Response to comments

"Hydrogeological controls on spatial patterns of groundwater discharge in peatlands" by Hare et al. describes a multifaceted approach to understanding two primary mechanisms for groundwater discharge in peatlands: matrix seepage and preferential flow path seepage. The research is primarily based in temperature observations (DTS, vertical temperature profilers, and infrared imaging), but also incorporates regional well data, ground penetrating radar, and coring information. The authors conclude that peatlands operate as part of the regional groundwater system, and that underlying basin curvature and peat thickness likely control patterns of discharge.

Hydrogeological controls on spatial patterns of groundwater discharge in peatlands

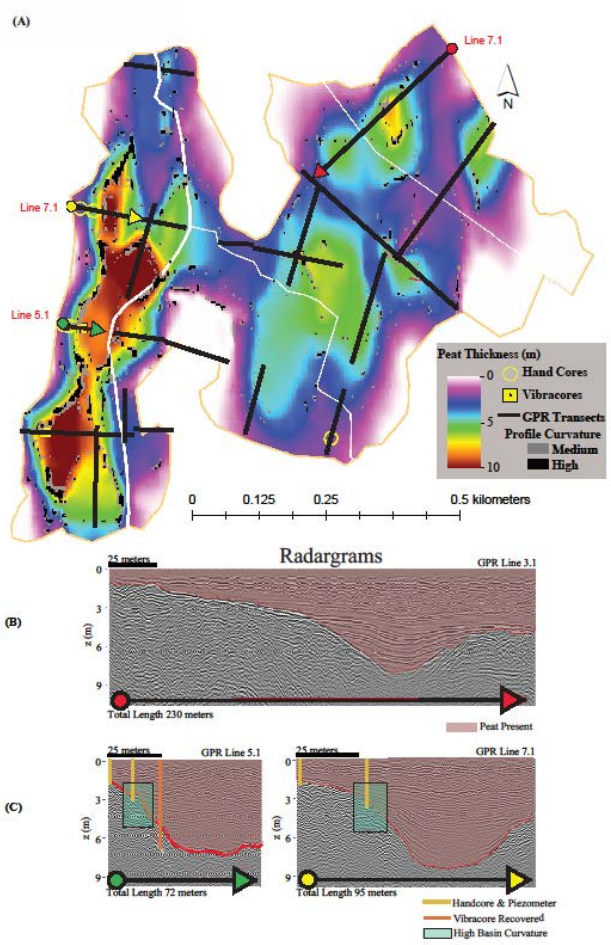
3. *Figure 2 shows a relatively important dip of the reflecting horizons. Is this an artefact of the vertical exaggeration? Or would it be useful to perform a migration in order to properly map the dipping reflectors?*

34. *Figure 2A. Use lower case "k" for "kilometers".*
Change made.

The dip depicted within the radargrams are emphasized due to the vertical exaggeration; however, is not an artifact of the visualization, as these depths were confirmed in seven locations with physical cores. Migration would be useful to reduce the point diffractions and may move the depth and dip of interface minimally, but would not change the relatively comparison throughout the site. Thus, as the purpose of this work was only depict the interface of the bottom of the organic matter and the sand matrix, and the slope is generally reviewed in a relative sense the additional post-processing was not deemed necessary.

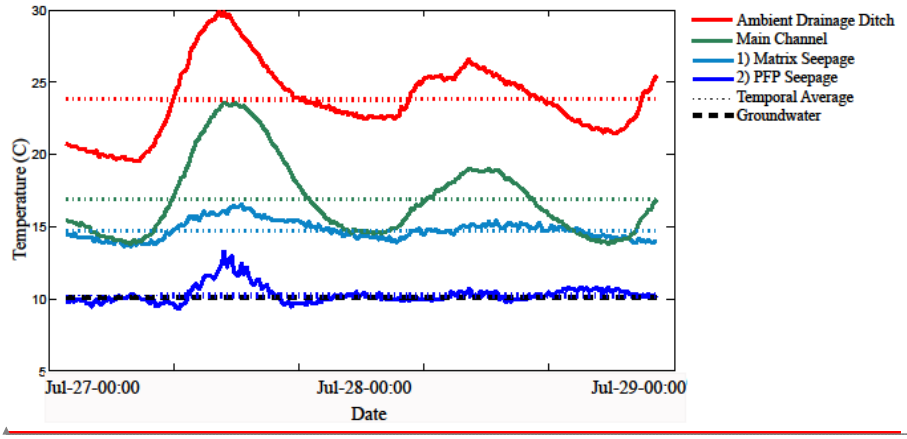
p. 11 It would be useful to have some air temperatures here to correlate with the

groundwater temperatures in the ditches and channel (Fug. 3).

We explored adding the air temperature to Figure 3 for reference; however, the noise of the signal caused by changes in solar radiation throughout the day is found to be distracting and the scale shifts taking the focus away from the seepage dynamics. In addition, as the seepage was recorded within the drainage ditch the drainage ditch temperature is the upper boundary condition not the air. For these reasons we authors feel that this edits is not necessary.

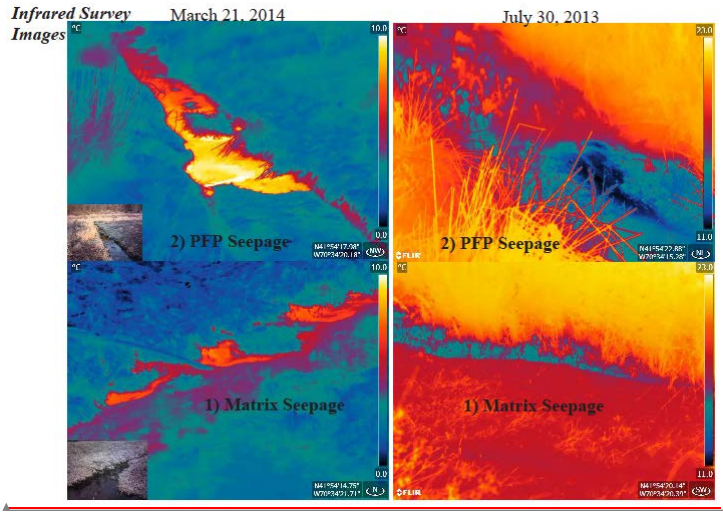
Discuss the limits of the methodology if the pictures (Fig. 4) were only taken at night.

How would the results differ if taken by day? Mention this in the methods section.

Hare et al (2015) provides an in depth analysis of the TIR method including data collection, specifically analyzing the TIR imagery data presented in this manuscript. An additional reference has been provided to describe that how day and night differences may or may not impact temperature results.

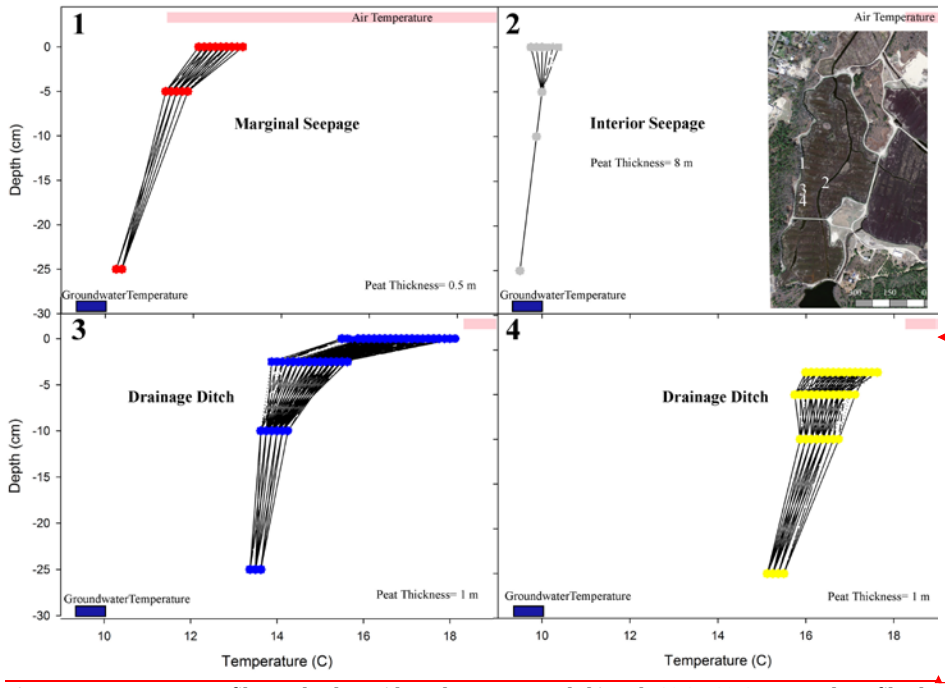
I have a minor specific question/comment regarding the interpretation of drainage ditch areas as upwelling zones. The vertical temperature profiles appear to me to possibly simply be responding to diurnal fluctuations.
As the drainage ditch locations temperature profile exhibit a concave downward structure with depth, these areas are characteristically upwelling; however, a thorough review of the calculations was completed, including a review of the parameters and corrections are warranted, as the upward flux through the drainage ditches are not as significant as previously indicated. The flux values have been modified to reflect the corrected range.

339-I'm not totally sold on this argument for upwelling in the ditches. I'm not an expert on thermal methods, but wouldn't the convexity of these profiles depend on the time of year and relative temperature of the air versus deep groundwater? The drainage ditch profiles don't look like upwelling to me - they look like conductive heating from above. Is it possible that the calculated upward flux is within the uncertainty of the input parameters?
Given that the DTS did not show any temperature anomaly, I think it's more reasonable to assume that there is little to no upwelling occurring here. However, if you're pretty sure the thermal modeling is well-constrained, then it makes sense to me to include this argument.
As discussed above, after review of the input parameters and final flux values, it is apparent that some simplifications were made. Values have been adjusted to more accurately reflect the range of parameters appropriate for peat, and while there is still flux upward, the value is lower in the drainage ditch locations. The parameters used in the 1D heat transfer equation are now included as Table 2, and referenced the Table in Section 2.2.3.

I think it would be useful to report on the parameters used in the 1D heat transfer equation and also to evaluate limiting conditions to determine whether the drainage ditches are actually upwelling zones.
I agree, the addition of the parameters used in the 1D heat transfer equation to the text would strengthen the manuscript. I have now included the parameters as Table 2, and referenced the Table in Section 2.2.3.

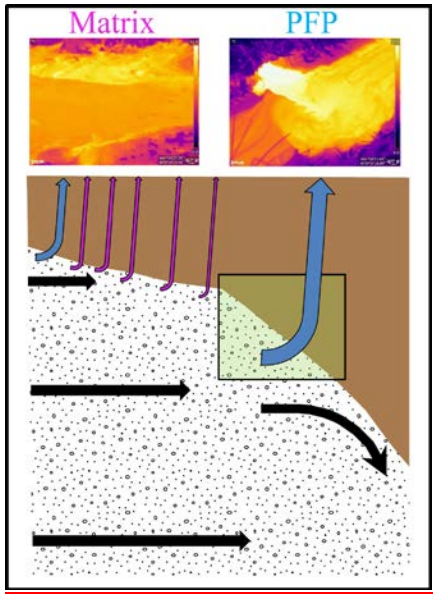
First of all it is not clear whether it is the result of a numerical model or a conceptual drawing. In the first case, details are totally missing and it is not obvious why the uppermost contour line of hydraulic head appears to be slightly wavy at some places.
   From this figure it seems that poorly permeable peat prevents from matrix seepage unless the peat thickness is sufficiently small; on the other hand, when peat thickness is relatively great, seepage may occur through preferential flow paths (PFPs) only. Can you provide quantitative statements which are conferred general validity from this single case study?

Do PFPs occur where the peat base is folded, as shown in Figure 9, only or might PFP occur elsewhere? Despite the extensive "Discussion" section, I was not able to find a clear answer to these questions.

36. *Figure 9. Linear dimensions are missing.*

However, a simple 3-D conceptual model of the sand/peat interface might be useful for explaining the geomorphological situation and flow directions.

p. 16 Would it not be better to introduce the conceptual model at the beginning to

help guide the reader throughout the text and provide a simple, conceptual 3-D model

extended from Fig. 9 for the whole study area?

After review of the figure and the reviewer's concerns, it does appear that Figure 9 is not clear. Figure 9 has now been updated to become more relevant and is now based on the field data from GPR line 7.1 to demonstrate that this conceptual model is representative of the observed data, and thus exhibits quantitative results.

This comment has been addressed by discussing the other locations where PFP seepages were observed in section 4 and section 5, as well the modifications to Figure 9.

Figure removed from manuscript

While a 3-D conceptual model would be helpful in explaining the full scale processes, it would be a very complex and busy image. I believe the updated 2D Figure 9 image provides the useful information for flow directions required for data discussion with combination of the Figure 2 interpolation image required to understand the peatland basin shape and the processes .

Introducing the conceptual model earlier in the manuscript, while helpful to walking through the methods would not make sense to the readers until the definitions of matrix and PFPs have been explored in relation to the GPR results, which occurs in the discussion section. Reference to figure 9 has been included in the early paragraphs of section 4.2 to help introduce the conceptual model as early as possible, as the data interpretation of Figure 7 must be discussed prior to the conceptual model. It is the aim of the study to use Figure 2 as the basis for the 3D conceptual site model in combination with the updated figure 9.
